Access Compliance Report

Public Rights-of-Way

(Curb Ramps)

Intersection ID: 11456	Main Street: E_W_T_HARRIS_BV	Cross Street: ROSECROFT_DR	Location:	N
ADA ID: AC89D6DD5084	Ramp Type: PerpDiag	Initial Pass/Fail: Fail	Overall Compliance: No	Severity Score: 35

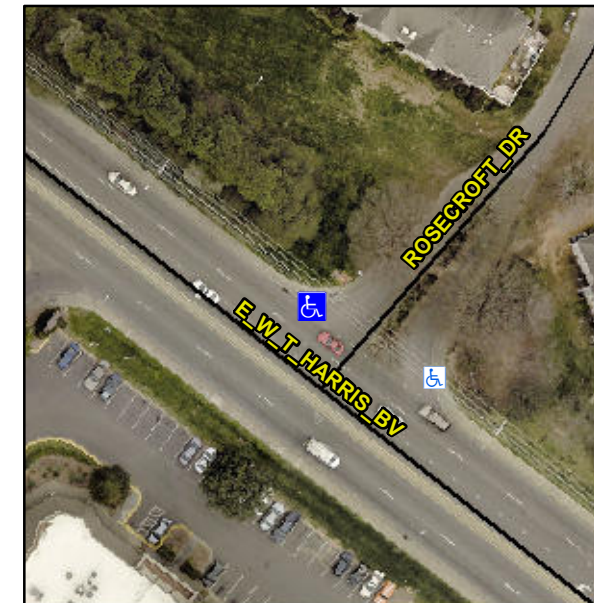
Not Found, R304.5.1, R304.2.2, R304.5.3

Compliance	Description	Data	Compliance	Description	Data
N/A	Ramp Length (in)	60.0	No	Ramp Slope (%)	12.9
No	Ramp Width (in)	41.0	No	Ramp XSlope (%)	2.9
N/A	Flare Type LT	N/A	N/A	Flare Type RT	N/A
N/A	Flare Slope LT (%)	N/A	N/A	Flare Slope RT (%)	N/A
N/A	Flare Traversable LT?	N/A	N/A	Flare Traversable RT?	N/A
N/A	Landing Length (in)	N/A	N/A	DWS Provided?	N/A
N/A	Landing Width (in)	N/A	N/A	DWS Contrast?	N/A
N/A	Landing Slope (%)	N/A	N/A	DWS Length (in)	N/A
N/A	Landing X Slope (%)	N/A	N/A	DWS Full Width?	N/A
N/A	Landing Curb? (Y/N)	N/A	N/A	DWS Offset (in)	N/A
N/A	Shared Landing?	N/A			
N/A	Gutter Ponding?	N/A	N/A	Gutter Slope (%)	N/A
N/A	Gutter Lip Ht (in)	N/A	N/A	Gutter X Slope (%)	N/A
N/A	Painted X Walk1?	No	N/A	Painted X Walk2?	No
	X Walk 1 Direction	To SW		X Walk 2 Direction	To SE
N/A	X Walk 1 Width (in)	N/A	N/A	X Walk 2 Width (in)	N/A
	X Walk 1 Slope (%)	3.9		X Walk 2 Slope (%)	2.3
	X Walk 1 X Slope (%)	1.1		X Walk 2 X Slope (%)	1.4

Remove & Replace Curb Ramp With Two New Directional Ramps or Equivalent.
